Auckland Council Comments on Melia Place

Melia Place is a Referred Project under the COVID-19 Recovery (Fast-track Consenting) Act 2020

Application name	Melia Place			
EPA reference	FTC000046			
Applicant/s	plicant/s Melia Development Limited			
Comments due by	28 February 2022			
Accessing the application	https://www.epa.govt.nz/fast-track-consenting/referred-projects/melia-place/the-application/

Figure 1: Bus Routes (Source: Auckland Transport)

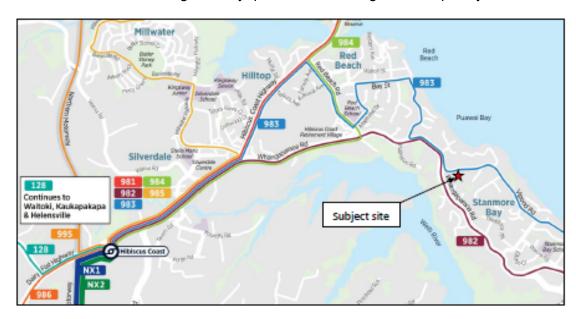
- 25. The TAR describes the public transport in the vicinity of the site. This includes two bus routes, the 982 on Whangaparāoa Road which is a connector service with a frequency of between 5 to 9 buses per hour in the peak periods in the peak direction of flow, and at least 30 minutes during the day in both directions. Route 983 which travels along Vipond Road then Whangaparāoa Road is a local service with a current frequency of hourly except in the peak direction of travel when there are four buses per hour at peak times. These routes are illustrated in Figure 1 below.
- 26. As can be seen from this figure, bus route 982 is a direct route along Whangaparāoa Road between the site and the Hibiscus Coast Station, whereas bus route 983 serves other suburbs along the route. According to Auckland Transport's journey planner, route 982

has a journey time of 14 minutes, whereas route 983 has a journey time of 23 minutes³. Route 982 is, therefore, significantly quicker with much greater frequency than Route 983.

- 27. The TAR states that the development is well-connected to public transport. For residents wanting to use the more frequent and quicker Route 982 buses to reach the Hibiscus Coast Station to connect to city bound buses, however, this requires them to cross the busy arterial road (Whangaparāoa Road). This would be challenging as there are no pedestrian crossing facilities to reach the westbound (city bound) bus stop. This would be a barrier to potential bus users, particularly the young or those less mobile. Similarly, there are no pedestrian crossing facilities on Vipond Road to cross from the eastbound (outbound) bus stop to the development, but this is considered less of a concern given the lower traffic volumes on Vipond Road.

- 28. The TAR states that bus passengers can avoid crossing Whangaparāoa Road to travel towards Hibiscus Coast Station by using the bus stop on Vipond Road. Whilst that may be the case, these buses are less frequent and less convenient as they do not travel directly to the station. The inconvenience of using the longer and less frequent buses on Vipond Road to avoid crossing Whangaparāoa Road is likely to be reduce the attractiveness of using public transport.

- 29. Improvements for pedestrians to reach the Whangaparāoa Road city bound bus stop, such as a pedestrian crossing or refuge island on Whangaparāoa Road, would ideally be provided to encourage use of public transport as an alternative to private vehicle travel. This would provide greater consistency with the Objectives and Policies of Chapter E27 Transport of the AUP(OIP) and in particular Objectives 1, 2 and 5, and Policies 1 and 2, and Chapter E38 Subdivision Objectives 4 and 6. The Applicant acknowledges the benefits of such a facility but considers that as this is an existing safety issue that would have wider benefits than this specific development and accordingly should not be required
